**World Forum for Harmonization of Vehicle Regulations****Working Party on Lighting and Light-Signalling****Seventy-first session**

**Other business – Any other business****Proposal for amendments to Regulation No. 113 (Headlamps emitting a symmetrical passing-beam)****Submitted by the experts from the International Motorcycle Manufacturers Association\***

Annex 8, amend to read:

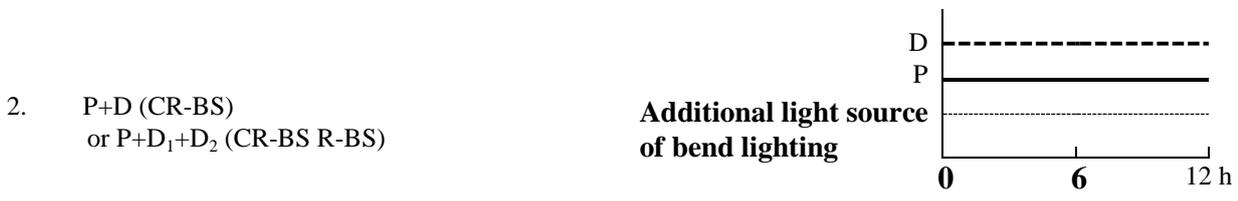
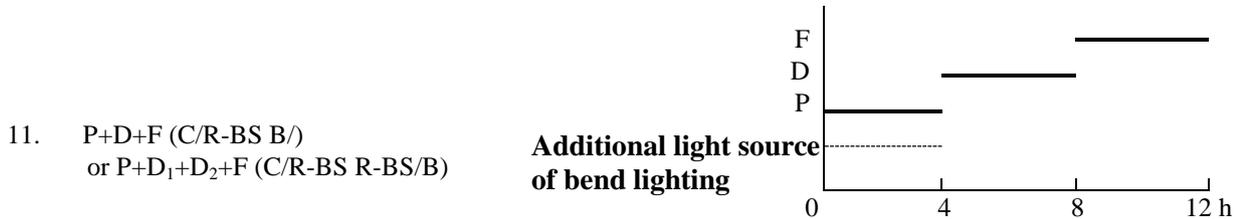
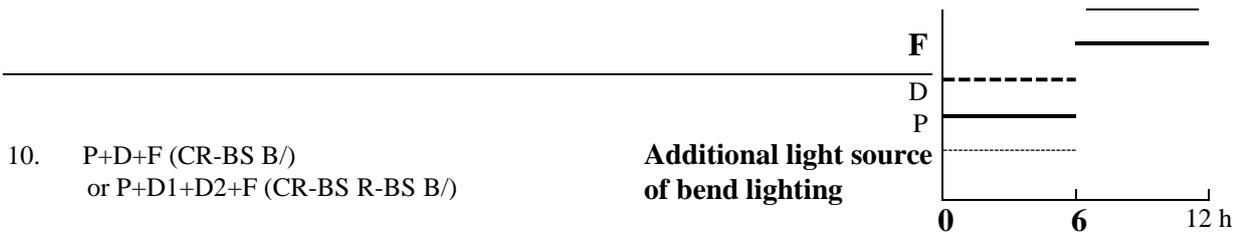
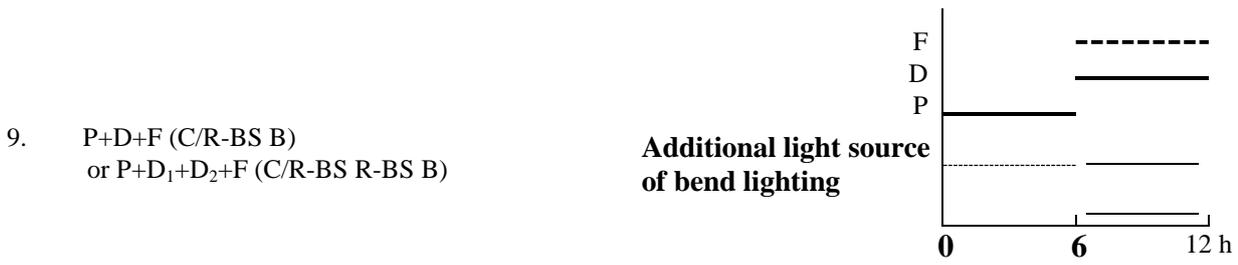
4. Original intention of the amendment (ECE/TRANS/WP29/2012/83) was only to add the dotted lines to the thermal cycle diagrams of Annex 8, in order to indicate the lighting

modes of additional light source(s) for bend lighting. However, in ECE/TRANS/WP29/2012/83, as well as CE4675 and ECE/TRANS/WP29/GRE/2012/15, the dotted lines (to indicate intermittent lighting) were erroneously indicated by continuous lines (to indicate continuous lighting). Furthermore, the change was accompanied by unintentional errors to the existing lines of the diagram; as shown below:

3. P+D (C/R-BS) or P+D <sub>1</sub> +D <sub>2</sub> (C/R-BS R-BS)	Additional light source of bend lighting	
4. P+F (C-BS B)	Additional light source of bend lighting	
5. P+F (C-BS B/) or C-BS/B	Additional light source of bend lighting	
6. D+F (R-BS B) or D <sub>1</sub> +D <sub>2</sub> +F (R-BS R-BS B)	Additional light source of bend lighting	
7. D+F (R-BS B/) or D <sub>1</sub> +D <sub>2</sub> +F (R-BS R-BS B/)	Additional light source of bend lighting	
8. P+D+F (CR-BS B) or P+D <sub>1</sub> +D <sub>2</sub> +F (CR-BS R-BS B)	Additional light source of bend lighting

Annex 8 (AS CORRECTED BY THIS PROPOSAL)

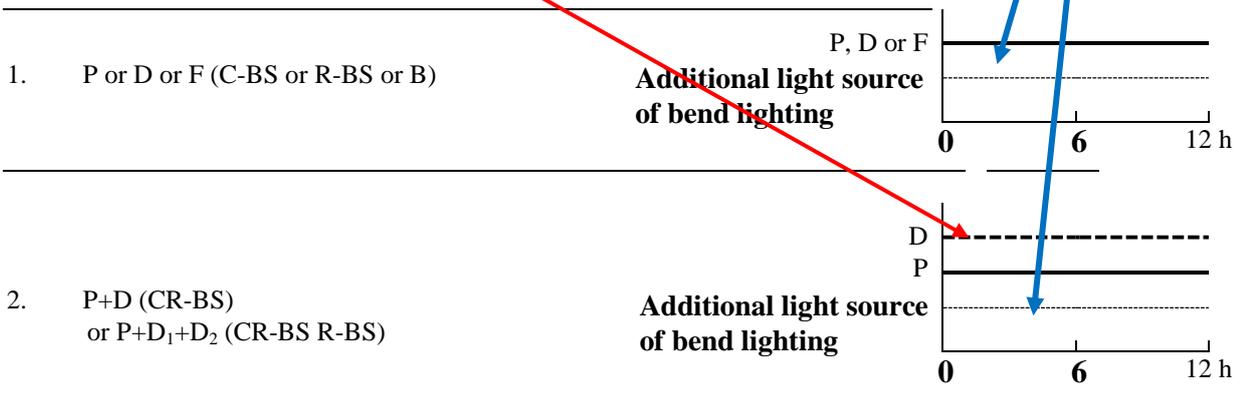
This dotted and bold line is erroneously changed to a continuous heavy line in WP29/2012/83

This dotted thin line is erroneously indicated by a continuous thin line in WP29/2012/83

(and similar mistakes are repeated in points 3 to 11 of Annex 8, ECE/TRANS/WP29/2012/83)
